ADDENDUM NO. 01

PROJECT: 125 CUMBERLAND STREET, LUNENBURG NOVA SCOTIA
CIVIC SQUARE BANDSTAND REHABILITATION

PROJECT NO.: #TOL2025008

ISSUED DATE: MAY 13, 2025

Photos 1,2,3: Existing roof ornament for repair re-attachment

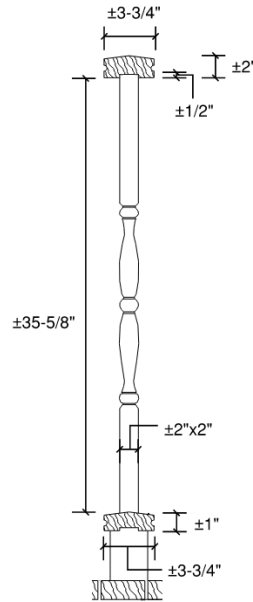
- .2 Detail 4/S3.1 becomes detail for Alternative Price.

- .1 New Base Bid: Repair metal work, replace wood base materials and re-attach existing roof ornament (photos below).
